Oregon Department of Transportation
**POWELL BOULEVARD
ROAD SAFETY AUDIT**

20th Avenue to 33rd Avenue
September 2014

Powell Boulevard Road Safety Audit (RSA)

20th Avenue to 33rd Avenue
Mile Point (M.P.) 1.76 to 2.49

Exhibit 9 Concept of Enhanced Crossing (Shoulder mounted RRFB could also be considered approximately 350' in advance of crossing, on a case-by-case basis.)

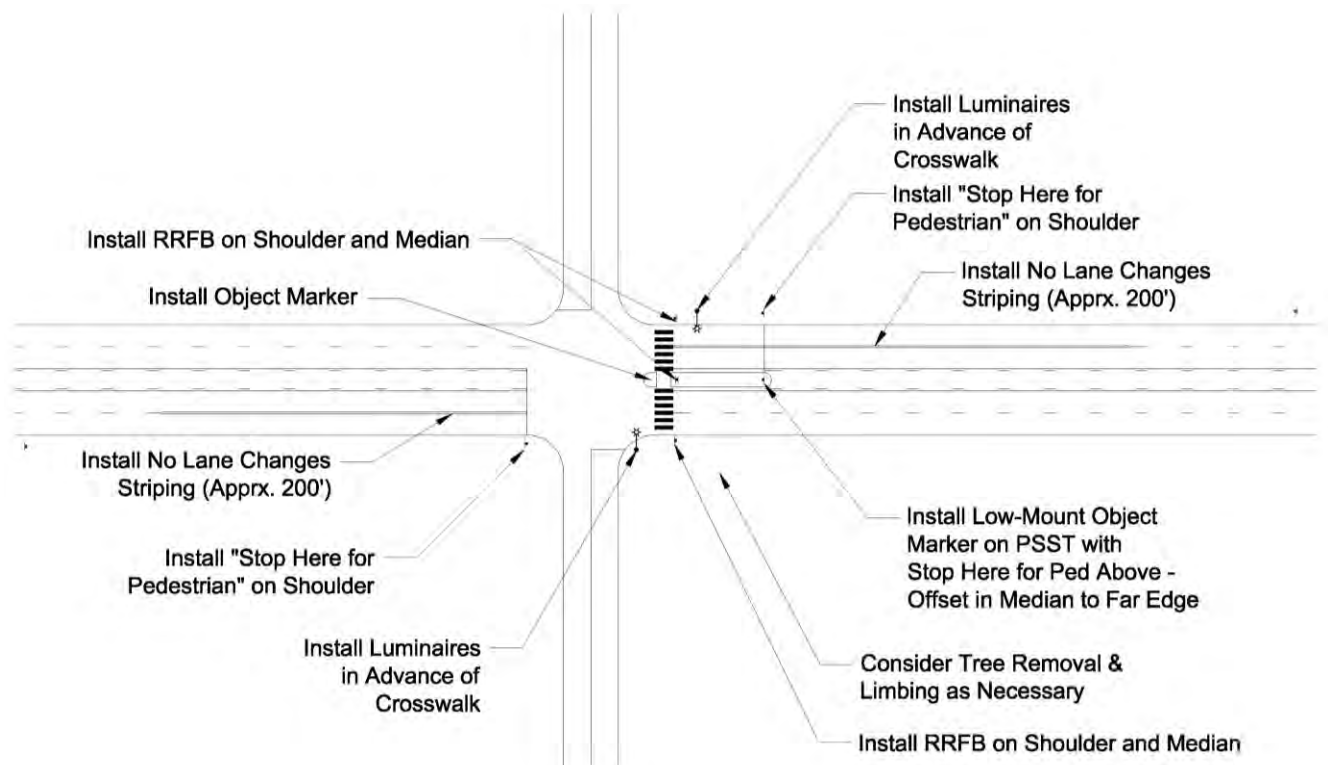
System-Wide Suggestions for Unpredictable Yielding at Pedestrian Crossings:

- Review bus stop locations relative to pedestrian crossings to determine if the stops located upstream from the crossings can be relocated downstream of the crossings.
- Upgrade unsignalized crossings to enhanced crossings with pedestrian refuge islands, visible advanced warning signage, “No Lane Change” striping, and rapid rectangular flashing beacons (RRFB), as shown in the concept in Exhibit 9. Exhibit 10 shows an example of a RRFB at a pedestrian crossing.
 - The median will allow a two-staged crossing for pedestrians.
 - Consistent crossing designs could be considered throughout the corridor (and similar roadways beyond the study area) to provide a consistent message for driver along the corridor.
- Provide pedestrian-scale lighting in advance of each unsignalized pedestrian crossing to illuminate the pedestrian in the crosswalk as illustrated in Exhibit 11. The illumination of

Exhibit 18 Flashing Yellow Arrow (FYA)

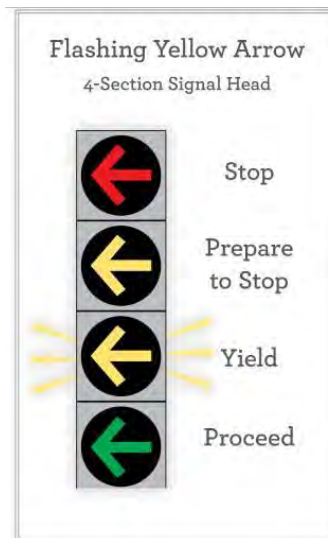
- Consider providing protected or protected/permitted left-turn phasing.
- Consider providing a leading pedestrian phase at signals when using protected/permitted left-turn phasing.
- Consider using the pedestrian function with the flashing yellow arrow (FYA) signals that will not allow a FYA to come up when a pedestrian call is placed. Exhibit 18 illustrates the FYA signal head.
- Consider prohibiting right turns on red at locations with:
 - A crash history involving right turning vehicles (21st Avenue) and/or involving pedestrians/bicyclists with right turning vehicles (26th Avenue), and/or
 - Limited sight distance (21st Avenue)

Exhibit 36 Concept of Crossing Improvements at Powell Boulevard/24th Avenue

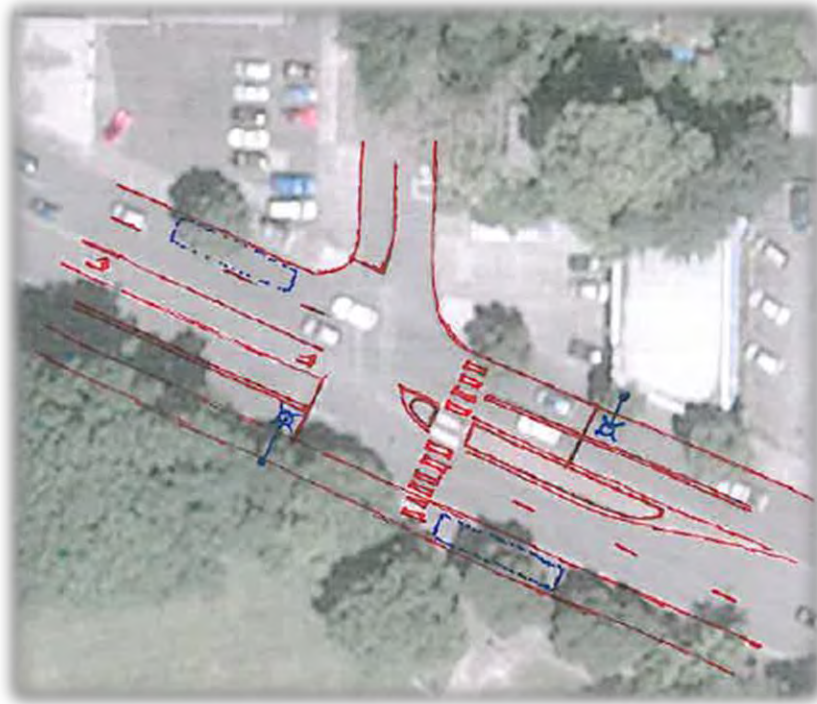
- Consider adding an RRFB and pedestrian scale lighting in advance of the crosswalk, as shown in Exhibit 36.
- Consider removing select tree(s) to increase visibility of crossing, signage, and pedestrians. Consider eliminating or relocating eastbound TriMet stop downstream of the crosswalk. The spacing between this stop and the next stop at 26th Avenue should be considered in the decision.

Exhibit 43 Locations of Crashes Involving Pedestrians (Involved or Injured)

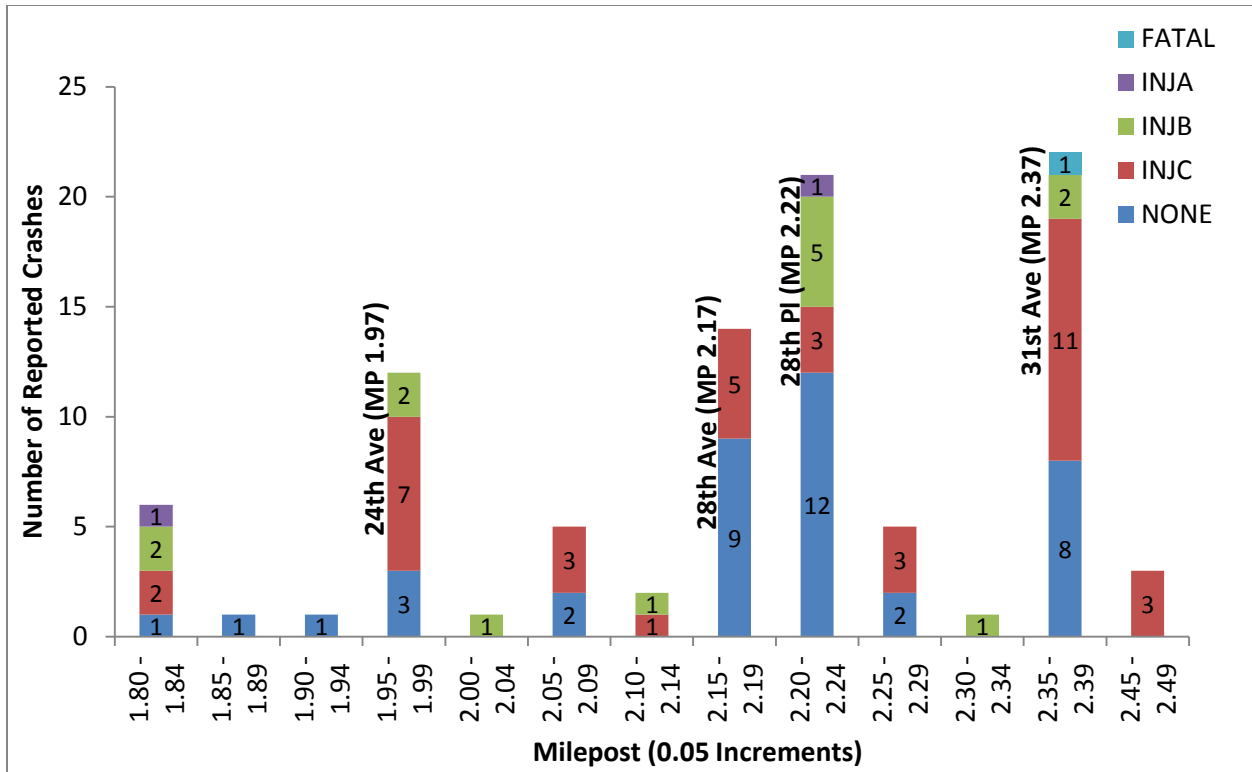
The crosswalk was observed to be difficult to see when approaching in the westbound direction because trees blocked the crosswalk signs. The team noted the crosswalk was particularly difficult to see during nighttime conditions. The transit stops are also located prior to the crosswalks. The recorded boardings at these transit stops were relatively low compared to others in the corridor. In addition, there is a food cart next to the motel that may have led to some pedestrian demand at this crossing.

Exhibit 46 Conceptual Intersection Improvements at Powell Boulevard/31st Avenue

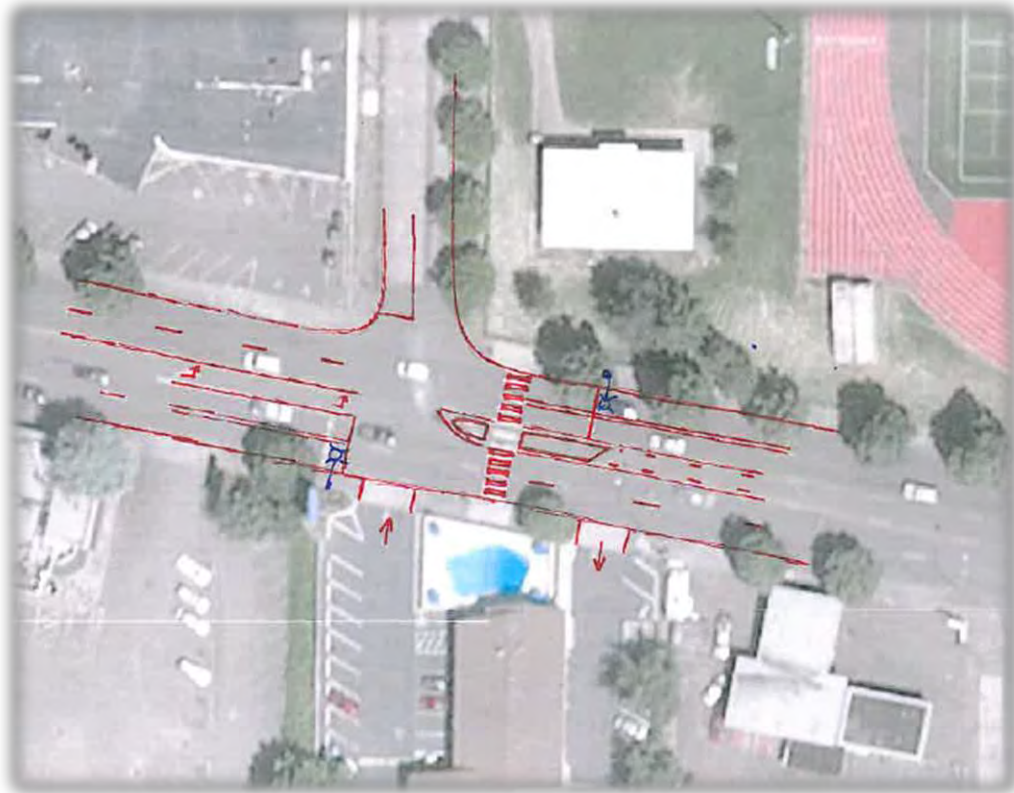
- Consider improving pedestrian crossing, as shown in the concept in Exhibit 46, to include:
 - Pedestrian refuge island;
 - RRFB;
 - No-lane change striping and advanced warning signs; and,
 - Pedestrian-scale lighting, placed in advance of the crossing.
- Consider improving signage and pavement markings at Motel 6 exit-only driveway.
- Consider removing the fence on northwest corner of Motel 6 property to improve sight distance.

Exhibit 49 Conceptual Intersection Configuration at Powell Boulevard/33rd Avenue

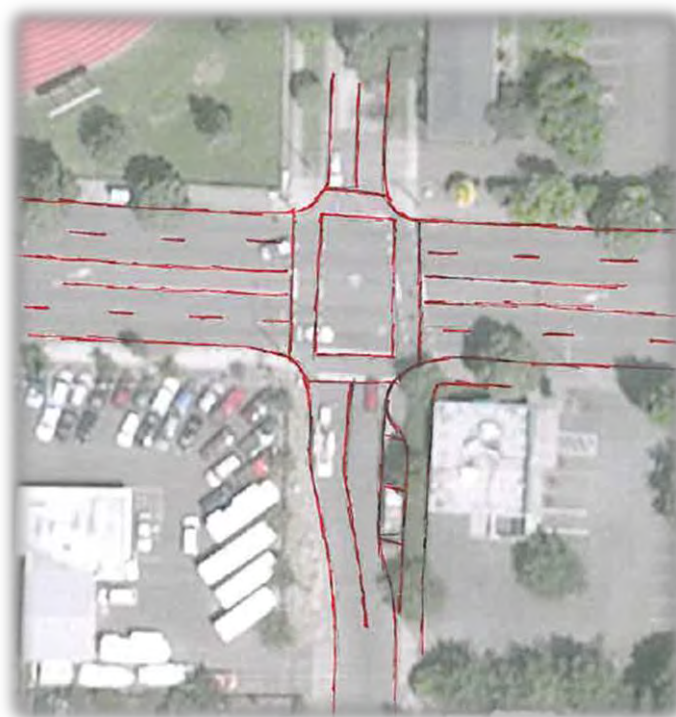
The signal has permitted left-turn phases for all approaches. The RSA team observed it was difficult to make left-turns from Powell Boulevard with the permitted phases. In addition, the cycle length was observed to be relatively long. Pedestrians were observed to cross during the Don't Walk time. Bicyclists were observed using the pedestrian push button after waiting for the signal to change, as illustrated in Exhibit 48. Although there was a bicycle detection symbol in the pavement on the side street approaches, it was unclear if the detector is functioning.

- Review signal timing and cycle lengths:
 - Consider pedestrian and bicyclist wait times;
 - Consider protected/permissive left-turn phasing from the mainline;
 - Consider providing an indication of bicycle detection to discourage impatience;
 - Consider running the signal at 33rd Avenue with half cycle compared to other signals within the corridor due to pedestrian/bicyclists frustration; and,
 - Consider installing a new signal with mast arms. Pole placement will be a focus to improve awareness of the approaching intersection as well as ensure adequate turning radii.

Exhibit 52 Corridor Option #1

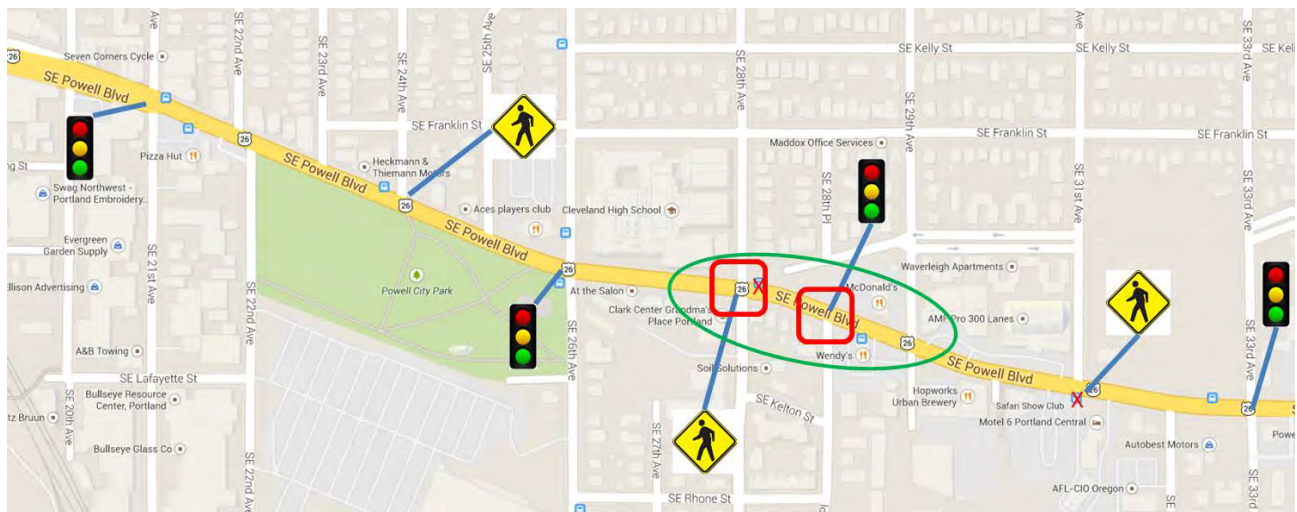
Option #1 is summarized in Exhibit 52, which includes a new traffic signal at 28th Place. This option allows for more consistent signal spacing along Powell Boulevard within the study area.

Exhibit 54 Conceptual McDonalds Site Plan Modifications Within Option #1

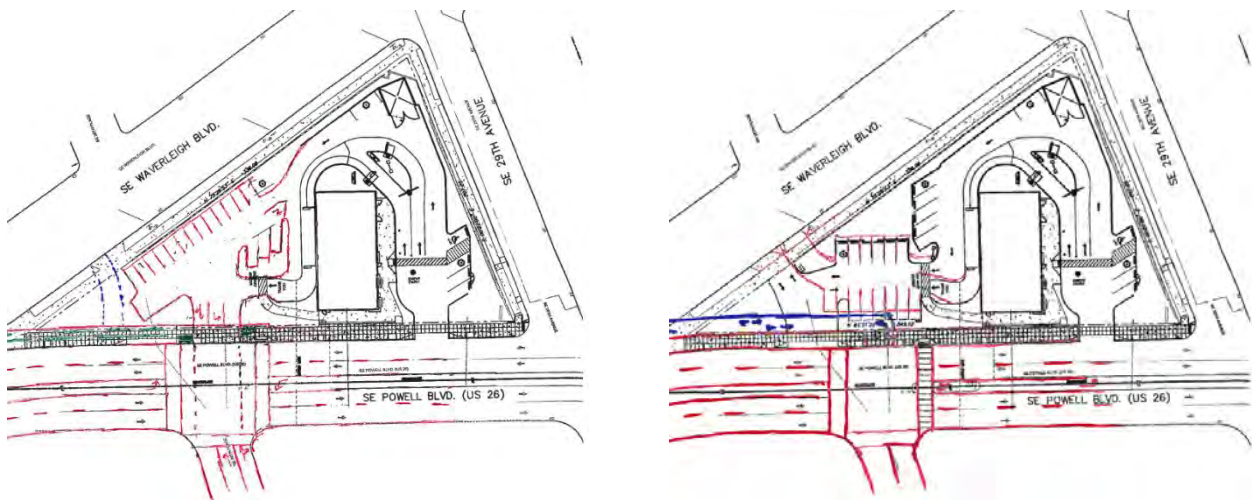
- The sketch on the right eliminates McDonald's access on Powell Boulevard and reroutes exiting motorists via Waverleigh Boulevard and 29th Avenue. The fourth and northern leg of this intersection will provide access to the bike route.

Exhibit 55 Corridor Option #2

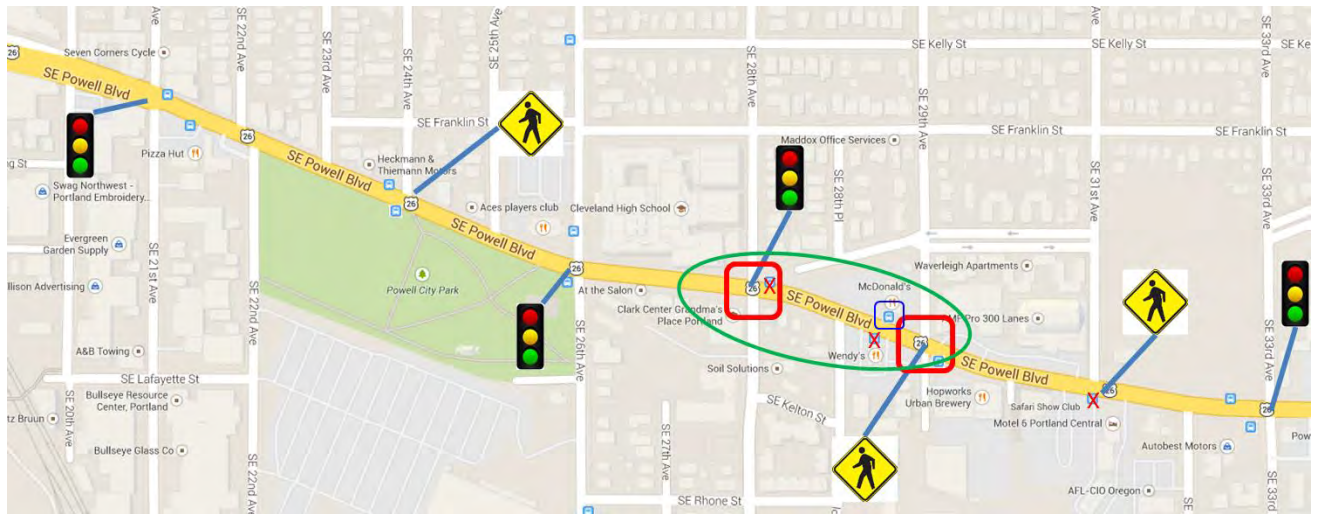
Option #2 includes a new traffic signal at 28th Avenue, as illustrated in Exhibit 55. This option will have two closely spaced signalized intersections.
